RE: ENERGY STAR™ Luminaires 2.1 Draft Comments

## Comments on Draft 1 - ENERGY STAR™ Luminaires v2.1

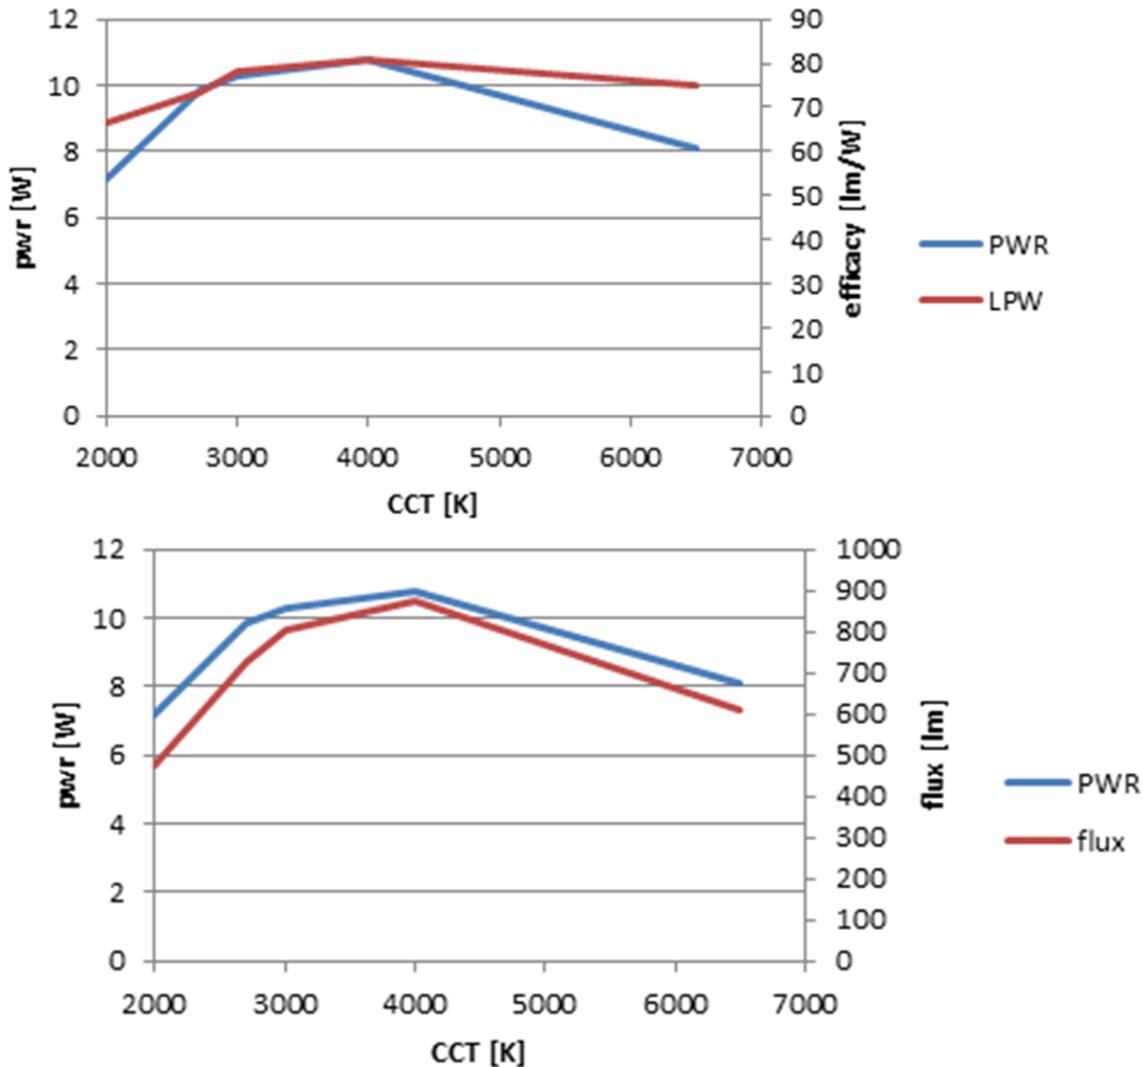
The “least efficient white light setting” is likely to be one of the ANSI endpoints (2700K or 5000K from Section 9.3) in most foreseeable designs. It is also likely to be a point with relatively low power consumption and low light output, and therefore will present some challenge for luminaire design. The figures below show how power, efficacy and light output will vary with CCT, for a hypothetical color-changing lamp. In the top figure, efficacy is lowest (of the ANSI white points) at 2700K. From the lower figure, at 2700K the flux is about 720 lm. The flux at 4000K, in contrast, is nearly 900 lumens (about 100 lumens higher than necessary to meet a specification of 800 lm, for instance). In order for this product to qualify for Energy Star in the

“surface mounted retrofits for diffused ceiling mounted lights” category, based on the least efficient white point, it would have to be over-designed to produce at least 980 lumens at the most consumptive point (higher actually, to allow some margin in the design).

We suggest that Energy Star require the complete photometric testing to be done at the most-consumptive ANSI white setting (with watts, lumens, chromaticity, and CRI reported at the default and minimum efficacy white points), instead of requiring full photometric testing and evaluation at the least efficient white light setting. This will be consistent with the Energy Star Lamps specification. This is likely to result in light output meeting the Energy Star specification at the most consumptive setting, but light output that may be lower than the specification at other ANSI white settings. It will, however, result in a lamp that is less over-designed, and lower power overall. Furthermore, because power is lower at all other white points, energy is being saved relative to the condition that the luminaire was qualified and tested for, no matter what the efficacy is at that setting.
